Product Change Notification: PCN-23-171653

M12 cordsets elimination of duplications

M12 cordsets elimination of duplication - Existing vs. Substitute products

**M12
straight
male**

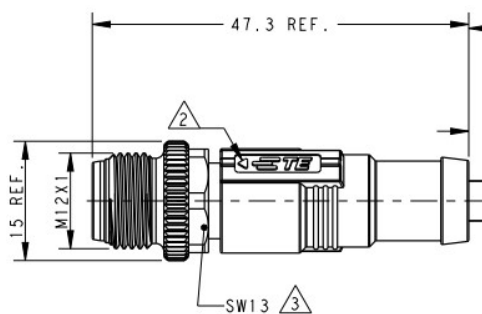
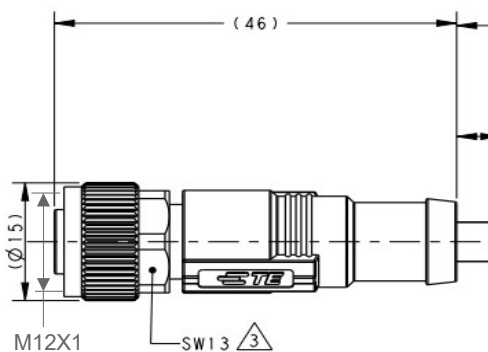
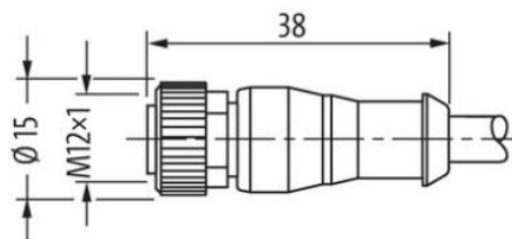
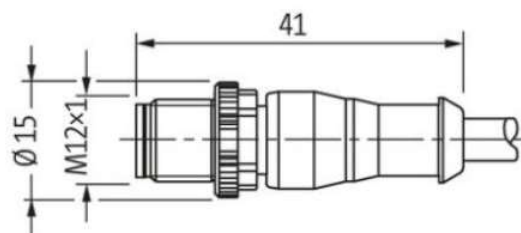
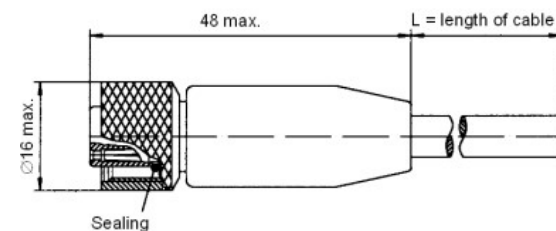
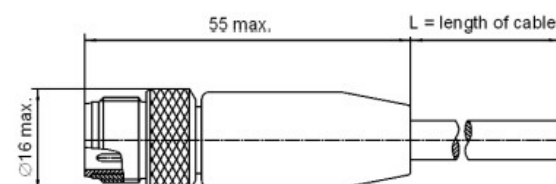
There are some slight deviation in outline dimensions among them, but both can meet IEC standard
